UNITED STATES PATENT AND TRADEMARK OFFICE

10/754,391

Office Action Summary

DETAILED ACTION

EXAMINERS FIGURE 1

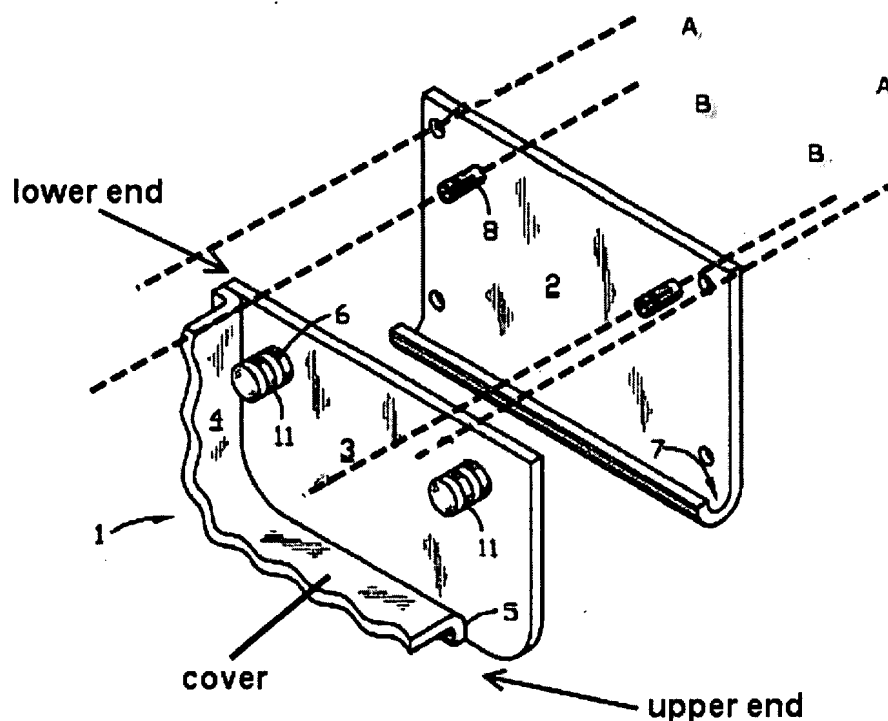
Regarding claims 1 and 8, Campbell discloses a saddlebag mounting system capable for use with a motorcycle having a fender support as claimed, including: a saddlebag 1 having (see Examiners Figure 1 below) a lower end and an upper end defining an upward direction, a cover being located at the upper end; a saddlebag frame 3 fixedly attached to the saddlebag; and a hook member at 5 integrally formed as part of the saddlebag, said hook adapted to couple a portion of the motorcycle and partially support the saddlebag; saddlebag frame 3 further includes first and second attachment members 6 configured to couple the saddlebag to a portion of the motorcycle; and

wherein the hook member at 5 is positioned above the positions of the first and second attachment members depending on how one looks at the figures, and furthermore wherein a central portion of the hook member at 5 is located between the attachment members.

Regarding claims 26 and 27, Campbell discloses a saddlebag mounting system essentially as claimed, including: a saddlebag 1 having (see Examiners Figure 1 below) a lower end and an upper end defining an upward direction, a cover being located at the upper end; a saddlebag frame 3 fixedly attached to the saddlebag; a hook member 5 integrally formed as part of the saddlebag said hook adapted to couple a portion of the motorcycle and partially support the saddlebag; first and second attachment members 8 spaced a distance from each other, the attachment members substantially inhibiting

movement of the saddlebag in any direction, including the upward direction when the saddlebag is coupled to the motorcycle, and wherein the hook member at 5 is positioned above the positions of the first and second attachment members depending on how one looks at the figures, and furthermore wherein a central portion of the hook member at 5 is located between the attachment members.

Regarding claim 17, the modified Campbell device discloses mounting axes (A in Figure 1 shown above) and attachment axes (B in Figure 1 shown above) in the claimed configuration including mounting axes through parallel spaced holes 10, and attachment axes oriented parallel each other and between said mounting axes.

Regarding the amended language of claims 1 and 26, they recite no structure that prevents a lower end, an upper end, and a cover from being defined as shown in Examiners Figure 1. It is not required that the saddlebag frame be specifically attached to the motorcycle in any orientation, rather that it be ***adapted*** to couple to a portion of the motorcycle. As such, one can simply flip the saddlebag frame 3 of Campbell upside down, and define an alternate upward direction that places the hook member 5 above the attachment members 6. Regarding the cover portion, no specific structure is recited in the claim as what is encompassed by the cover, and as such Examiner is considering the gusset portion 4 of the saddlebag to be a cover.

Examiners Figure 2

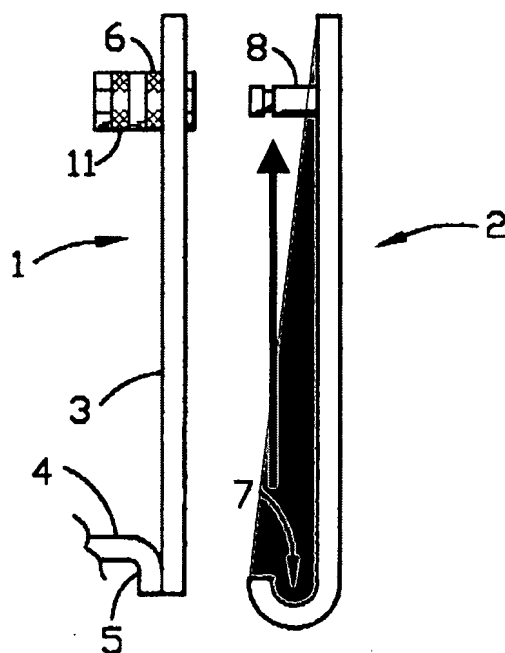
mount including bar member 2 having a cavity (shown in Examiners Figure 2 shaded in) formed within the lip 7, the cavity having an opening which can face in any number of directions, including away from the saddlebag and toward the fender support, and wherein first and second attachment members 8 of the bar are disposed within the bounds of cavity.

Regarding claim 18 the modified Campbell device discloses a saddlebag mounting system with saddlebag 1, a saddlebag mount including bar 2 extending along the motorcycle, and a saddlebag frame 3, which engages the bar and supports the saddlebag, wherein the bar defines a cavity (shown in Examiners Figure 2 shaded in) formed within the lip 7, the cavity having an opening which can face in any number of directions, including away from the saddlebag and toward the fender support, and wherein first and second attachment members 8 of the bar are disposed within the bounds of cavity.

Regarding the orientation of the cavity in claim 9 and 18, the cavity of Campbell as shown in Examiners Figure 2 is considered to face in any number of direction, including up and away from the saddlebag frame (as indicated by the arrow originating from the shaded area). Furthermore, claim 9 only requires that there be a saddlebag mount and a saddlebag frame which are engageable, but are not specifically connected.

As such, one could simple place the saddlebag frame 3 on the opposite side of the motorcycle as the saddlebag mount, such that the cavity faces away from the saddlebag and toward the fender support.
